HISTORIC AND DESIGN REVIEW COMMISSION

May 20, 2020

HDRC CASE NO:	2020-187
ADDRESS:	523 E PARK AVE
LEGAL DESCRIPTION:	NCB 1753 BLK 4 LOT 13
ZONING:	RM-4,H
CITY COUNCIL DIST.:	1
DISTRICT:	Tobin Hill Historic District
LANDMARK:	House
APPLICANT:	Tania Serra/BLUESEA ENTERPRISES LLC

The applicant is requesting a Certificate of Appropriateness for approval to construct a 1-story rear carport.

⁵²³ EPARK

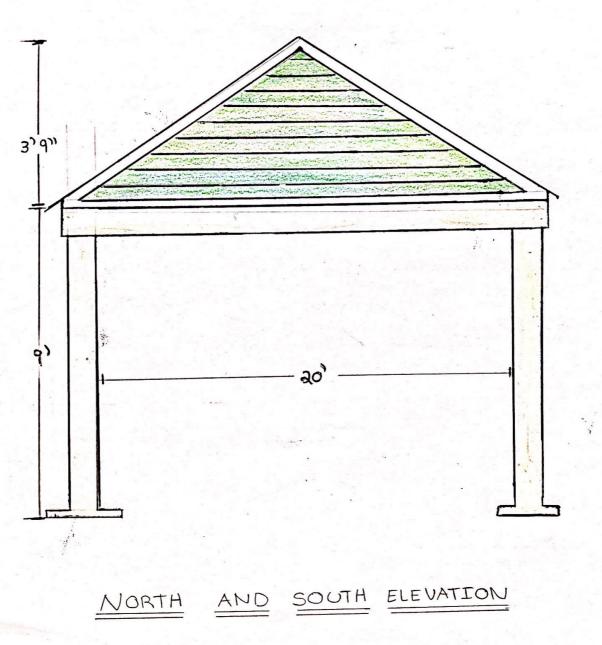
- c. ORIENTATION AND SETBACK The applicant has proposed to orient the new accessory structure towards the street. Guidelines 5.B.i and 5.B.ii for new construction stipulate that new garages and outbuildings should follow the historic orientation and setbacks common in the district. Staff finds the proposal for orientation consistent with the Guidelines. The rear setback is also consistent with historic precedents in the Tobin Hill Historic District, but staff has not seen a site plan that indicates the relationship of the placement of the structure to existing property lines. The applicant is responsible for complying with all zoning setback standards and filing for a variance with the Board of Adjustment if applicable.

- d. SCALE & MASS The applicant has proposed a 1-story carport structure with a gable roof. The structure will measure approximately ten feet in height. The Historic Design Guidelines state that new construction should be consistent with the height and overall scale of nearby historic buildings and rear accessory structure. The scale of the proposed structure does not impact or visually compete with primary structure on the lot or nearby historic structures, and will visually match the height of the carport located directly to the south on a neighboring property. Staff finds the proposal consistent with the Guidelines.

- e. ROOF The applicant has proposed a gable roof form for the carport. The roof will be constructed of metal to closely match the materiality of the primary structure. Staff finds the proposal consistent with the Guidelines, but has not seen a material specification.

- i. That the columns be a maximum width of 6 inches with a proportionate base and capital.
- ii. That the applicant provides final permit-level drawings, including elevations and a site plan with dimensions, to staff for review and approval prior to the issuance of a Certificate of Appropriateness.
- iii. That the applicant submits final material specifications to staff for review and approval.
- iv. That the applicant meets all setback standards as required by city zoning requirements, and obtains a variance from the Board of Adjustment if applicable.
